Rev 4 PCBs added rework to trace layout

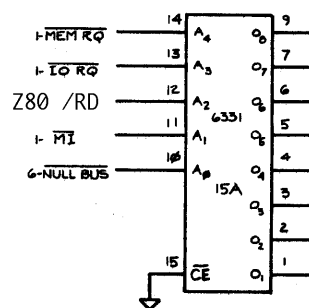
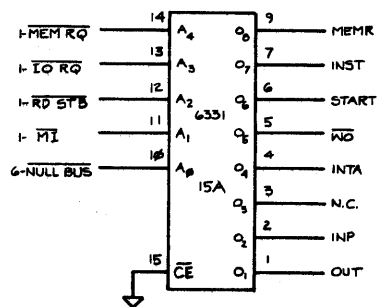
Cut off pins 8 and 9 of 16B, jumper 8 and 9 together on solder side of board

Lift pin 12 of 15A, connect to 16B-8 on component side

On circuit side, cut trace coming from 10A-12
Jumper 2A-10 to feedthrough on end of cut trace
Jumper 10A-12 to 2A-8
Jumper 3C-8 to 2A-9

Lift pin 10A-6 out of socket
On circuit side, jumper 10A-6 to 15A-15

Rev 3 and 4 replace the 6331 with a 82S153
On the component side of Rev 3/3A boards lift
pin 15A-3 and jumper to 16B-8 /RDSTB replaced with Z80 /RD
